DEVELOPMENT REVIEW BOARD  
**SUPPLEMENTAL SUBMITTAL**

PROJECT NO. PR-2018-001579

SUBMITTAL DESCRIPTION: Based on the comments from the DRB Hearing January 5, 2022 we requested a deferral

**RE: PR-2018-001579 – WINROCK TOWN CENTER, SI-2021-00304 SITE PLAN, SI-2021-00305 SITE PLAN AMENDMENT, SUMMARY PLAT (PLAT OF EASEMENTS ONLY)**

PROJECT TITLE WINROCK TOWN CENTER 2100 LOUISIANA BLVD.	JOB NO. 	DRAWN BY 
PROJECT MANAGER 	SHEET TITLE DRB EASEMENT EXHIBIT

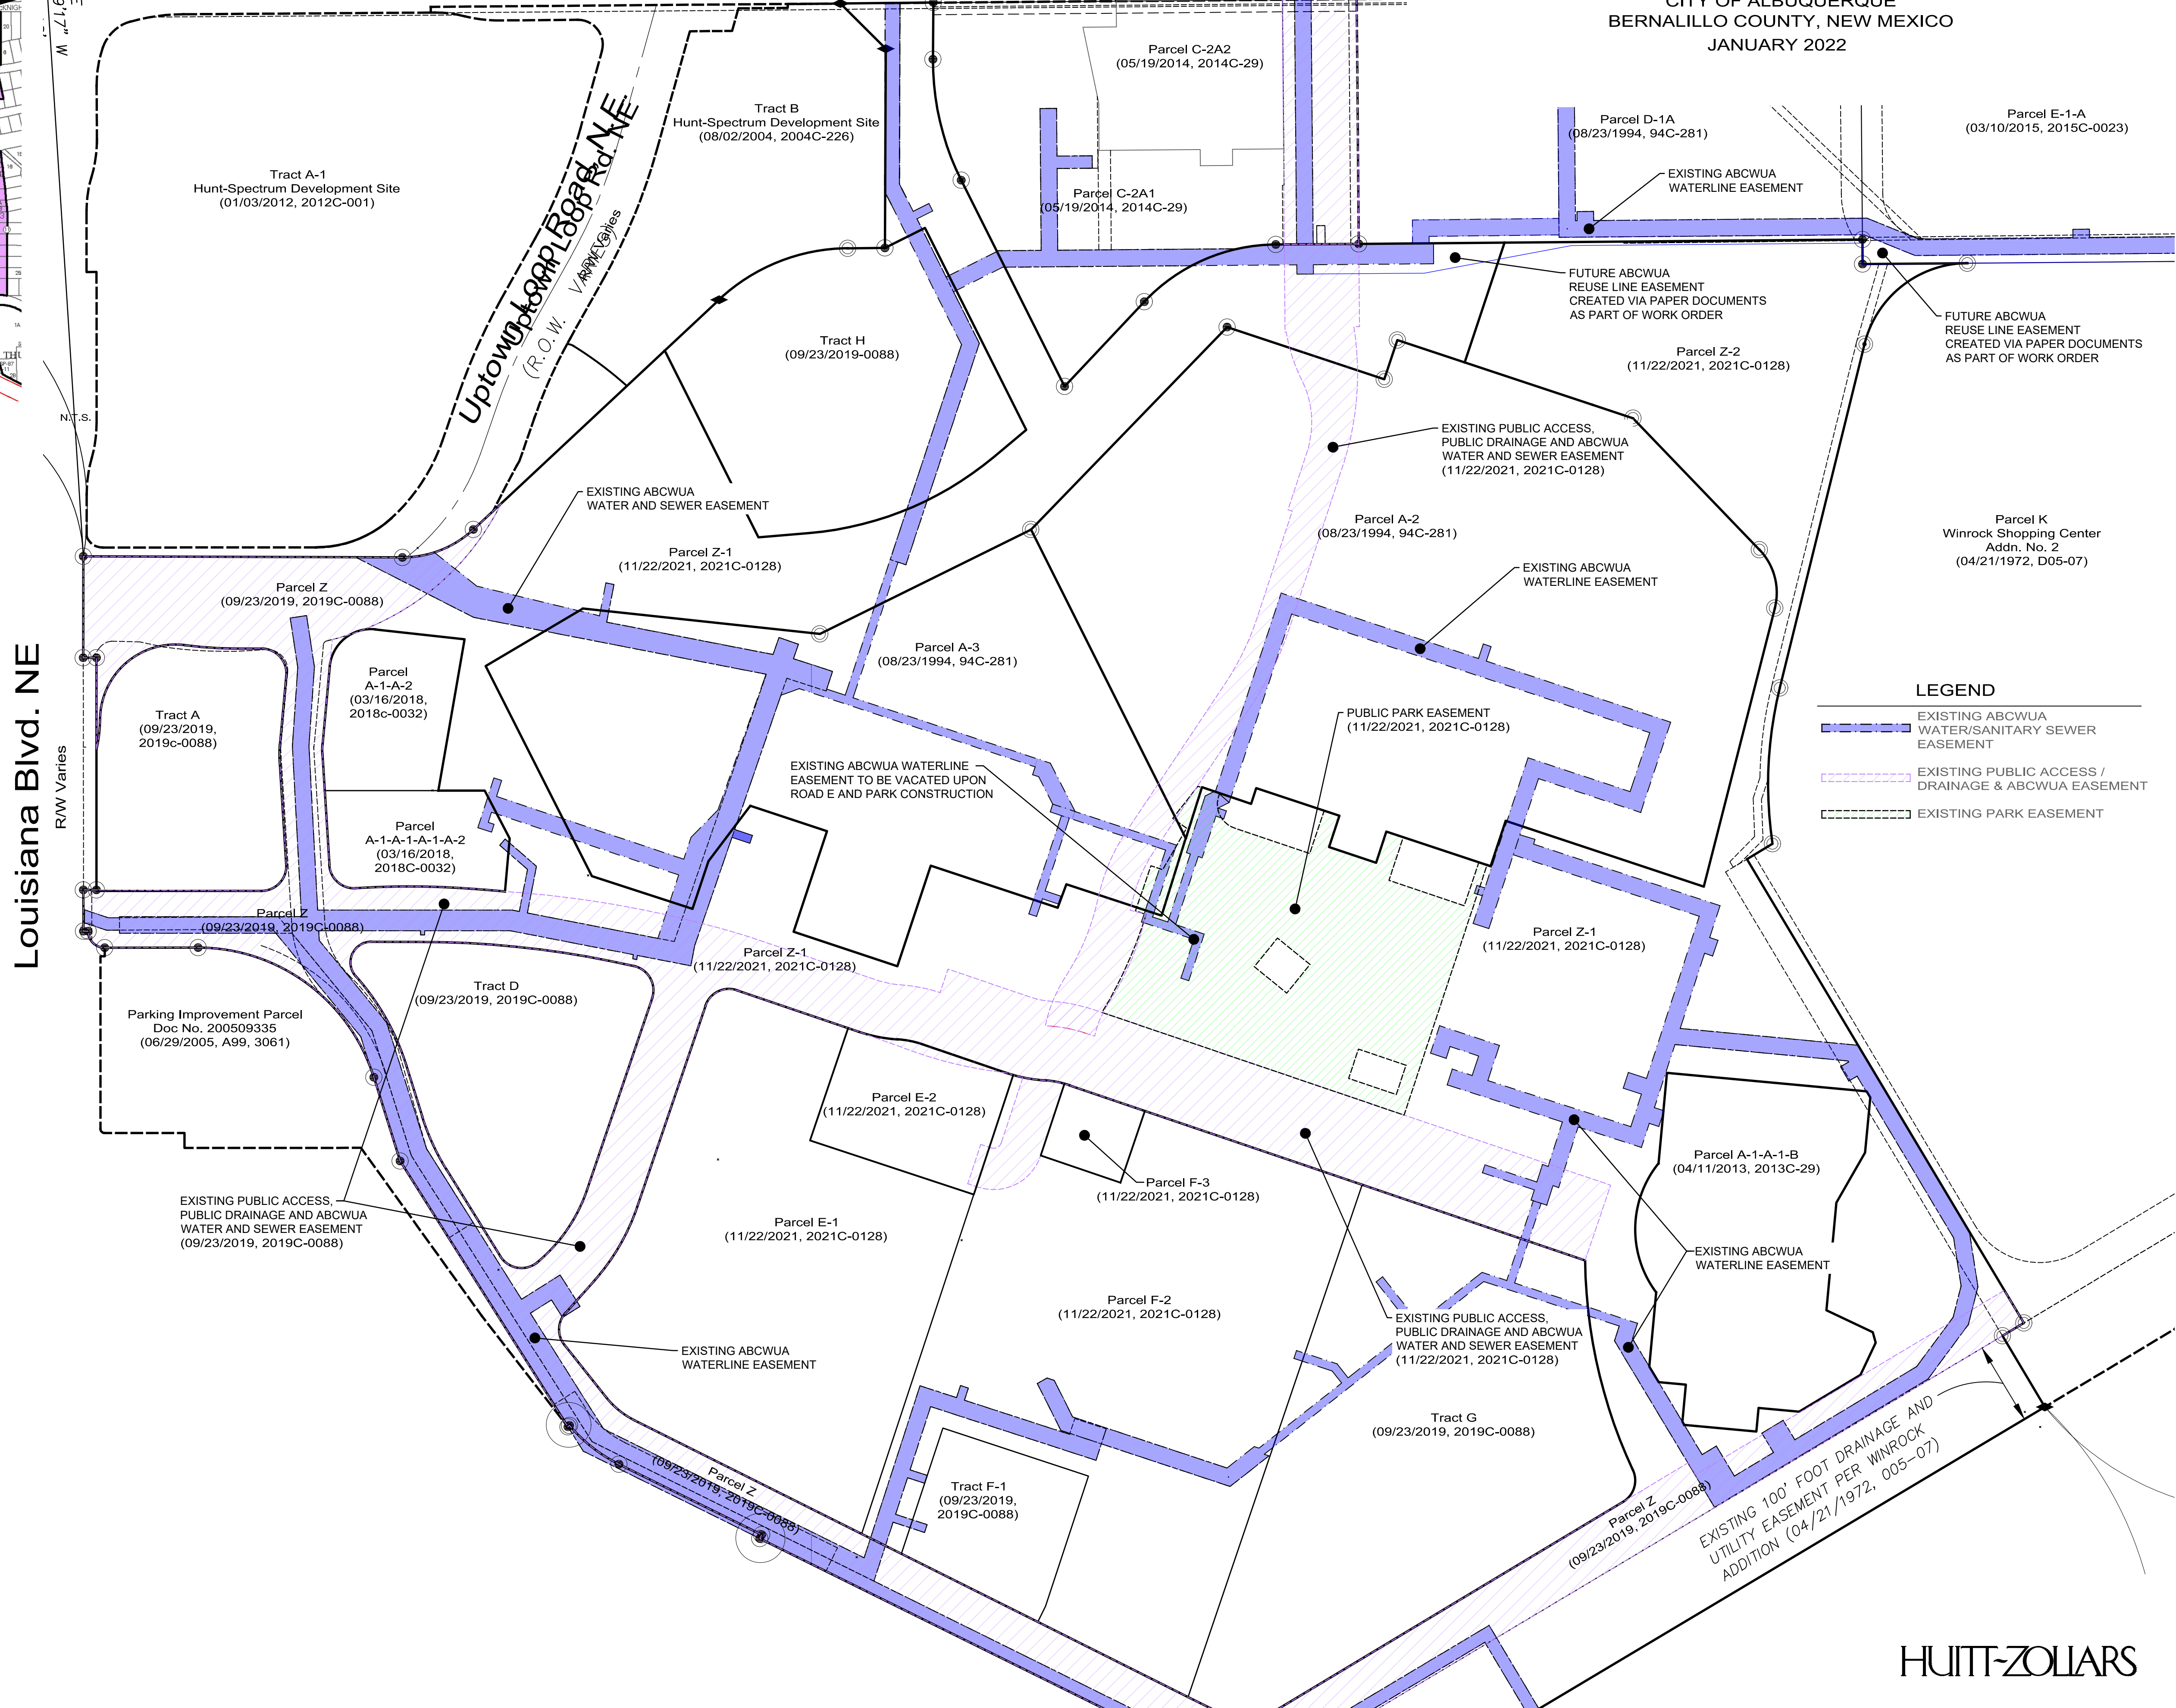
iv. PREVIOUS COMMENT: Please demonstrate sufficient easements for the proposed reuse lines, and any other public water and public sewer lines not currently within easements. The easement map provided with the plat does not appear to show easements for all the public lines, in particular the reuse running through the park and the initial sewer connection to existing manhole.

**1. Applicant Response: Easement Ex. Added.**
